# UNITED STATES PATENT AND TRADEMARK OFFICE

APPLICATION NO.	FILING DATE	FIRST NAMED INVENTOR	ATTORNEY DOCKET NO.	CONFIRMATION NO.
10/051,327	01/22/2002	Mary L. Bussler	0981/1	2715

**Office Action Summary**

## **DETAILED ACTION**

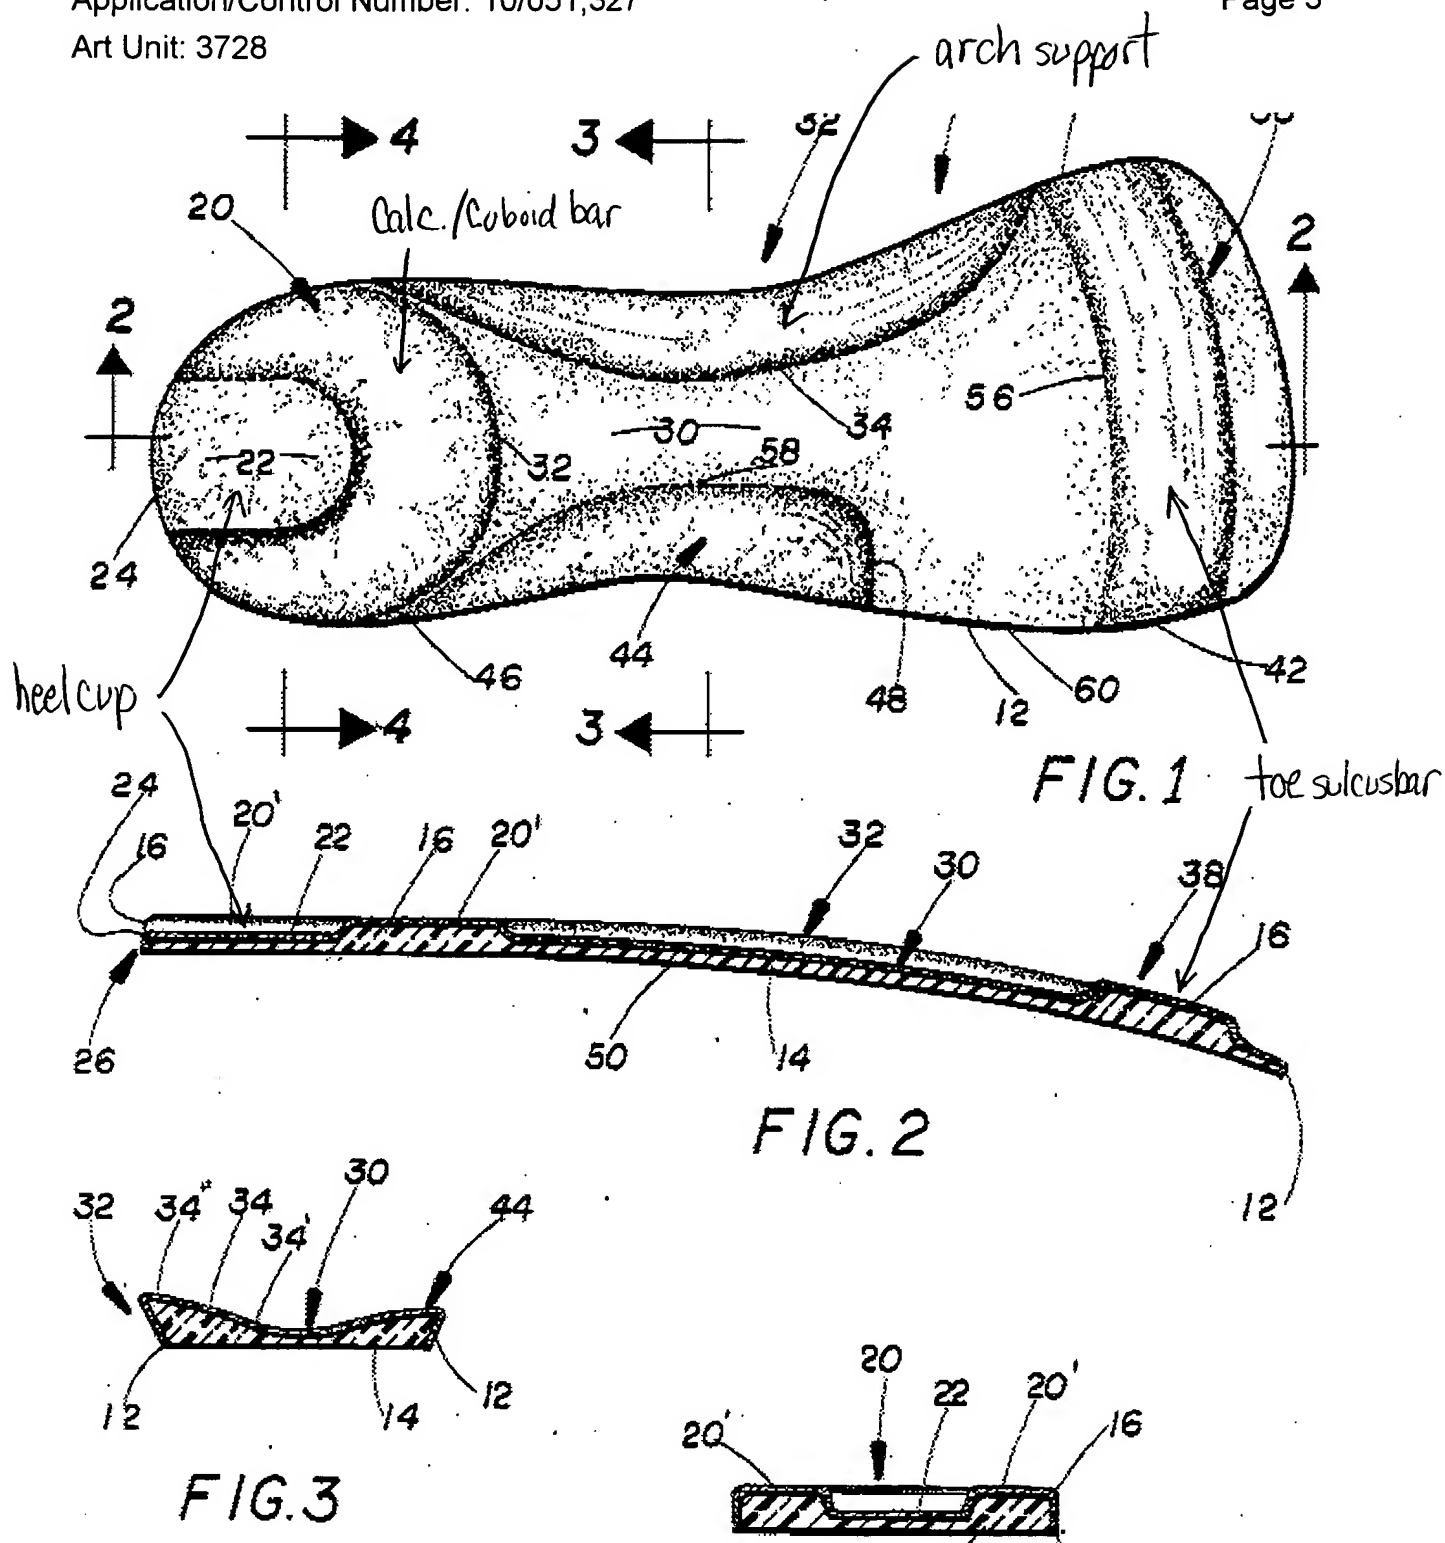
3. Claims 10,15-19,24-28,30 are rejected under 35 U.S.C. 102(b) as anticipated by or, in the alternative, under 35 U.S.C. 103(a) as obvious over US 4955148 (Padilla).

Padilla teaches the combination of a high-heeled shoe (see col. 1, lines 12-25) and a footbed (foot support assembly) as claimed, see the marked-up figures below. The foot support provides proper fitting within a give shoe style, see col. 2, lines 5+.

Padilla doesn't show the high-heeled shoe (otherwise known as pump shoes) but it is well known in the art for them to have an upper, a toe box and a heel having a height of at least 1 inch, and some being more than 3 inches. To the extent that Padilla doesn't teach a high-heeled shoe as claimed, the examiner takes official notice that high-heeled shoes having a toe box and heels of such height are well known and conventional in the art. Therefore, it would have been obvious to provide the shoe of Padilla with a high-heeled shoe, to provide proper support and balance to high-heeled shoes.
